CUP12-00046 / Boise State Alumni Association

Summary

Planning Division Staff Report

File Number CUP12-00046
Applicant Boise State Alumni Association
Property Address 1173 W. University Drive
Public Hearing Date September 10, 2012
Heard by Planning and Zoning Commission
Analyst Joshua Johnson
Reviewed by Cody Riddle

**BOISE STATE UNIVERSITY
ALUMNI AND FRIENDS CENTER
SITE PLAN**

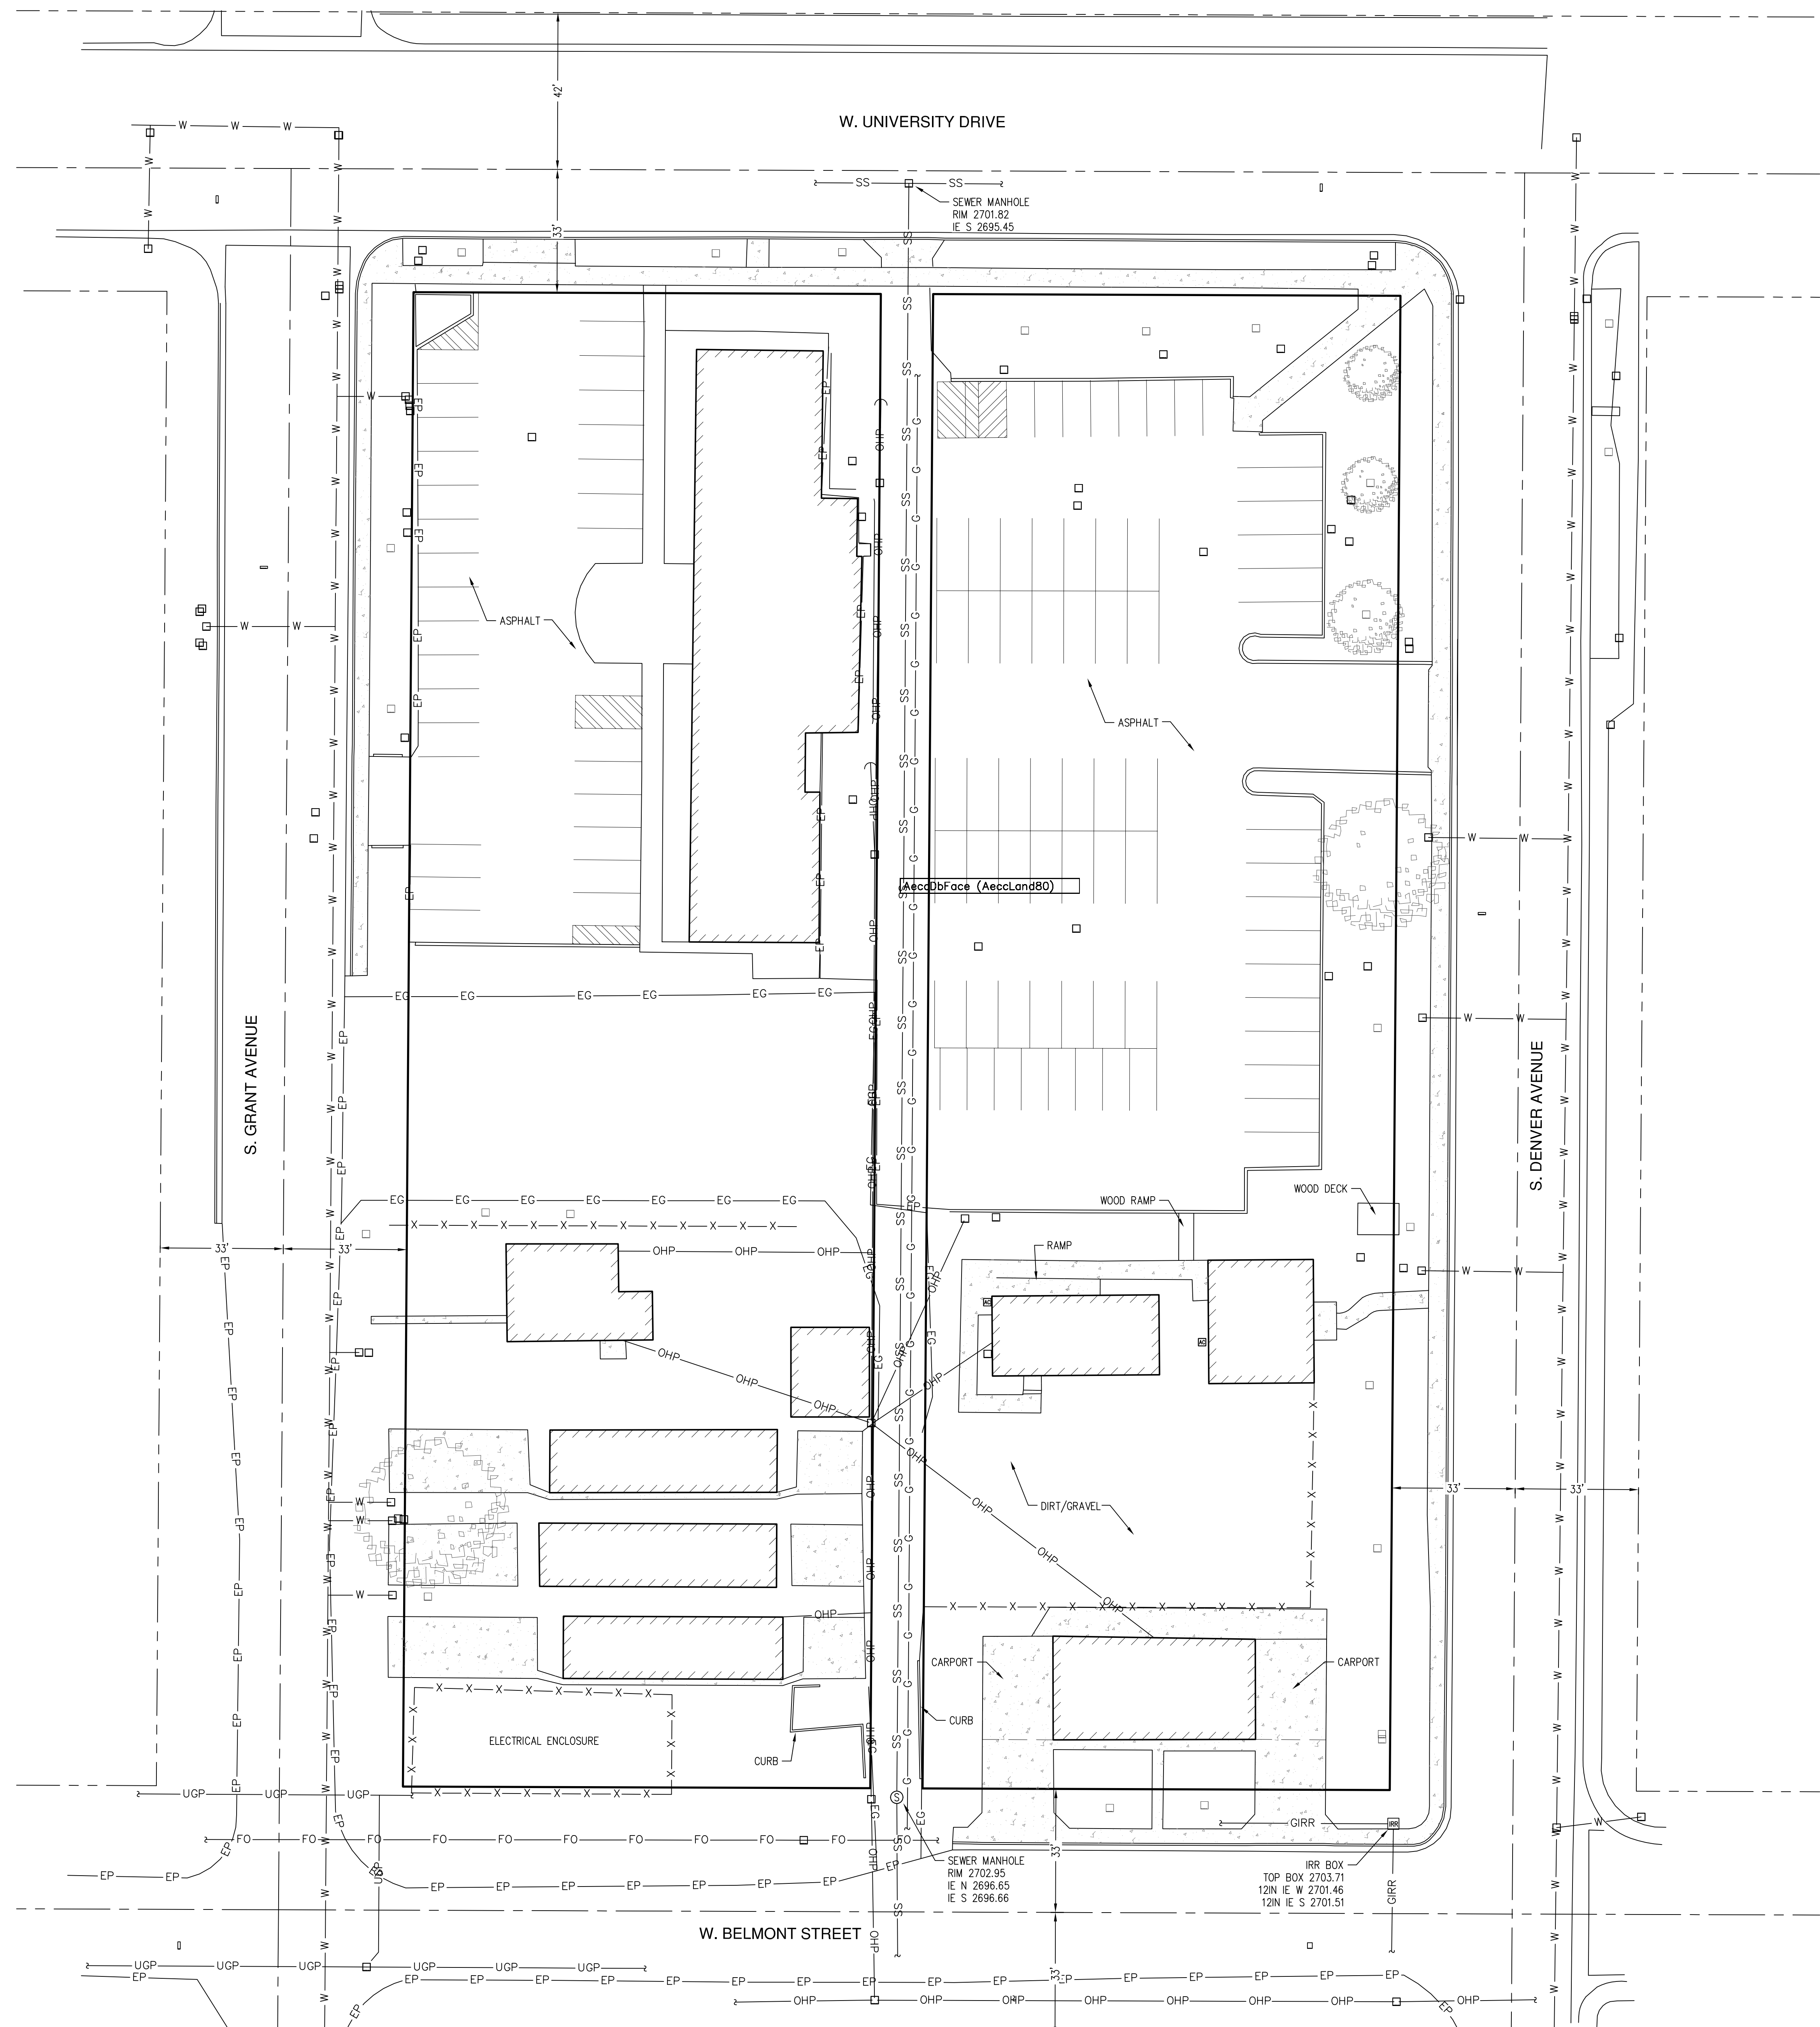
Staff is recommending conditional approval of the alumni center and its associated variances due to the low intensity nature of the use and its location on the Boise State campus. The subject property is at 1173 W. University Drive on the northeast corner of the campus and is within the approved 2005 Master Plan where the site is designated for an alumni center. The site is comprised of the current alumni center with parking and some buildings being used for miscellaneous campus support. The new alumni center is a four-story building seventy feet in height that will be utilized for office space and events related to alumni activities. The project requires a general exception as a recent rezone executed by the university did not include the parcel at the southeast corner of the block, although they do own it. The general exception would allow the standards of the U zone to be applied to the R-2 property. The variance is for parking facilities located along what is the campus boundary along Denver Street. A twenty foot setback at the edge of the campus is required but the applicant would like to apply setbacks similar to the City's standards for parking facilities along streets.

There is additional distance provided for buffering within existing right-of-way as the applicant's property lines where the variances are needed are sixteen feet from the edge of curbing. This will provide additional distance between the parking and the street.

The University zoning district uses an overall parking count for the entire school. This project is unique because it will have designated employee parking and the rear lot will be reserved when there are events for a total of 78 spaces. This should provide a measure of protection for the residential and businesses across Denver Street.
